SERVICE BULLETIN

APPLICABILITY: 2010-2017 Legacy and Outback

NUMBER: 04-15-17

SUBJECT: Steering Column Tilt Lock Information

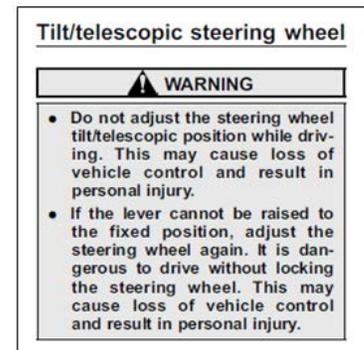
IMPORTANT NOTE: Warnings regarding the tilt and telescopic steering column are described in the Owner's Manual as shown here. If the tilt lock lever is not pushed up all the way, steering function is **not** affected however; the vehicle should not be operated should this condition occur.
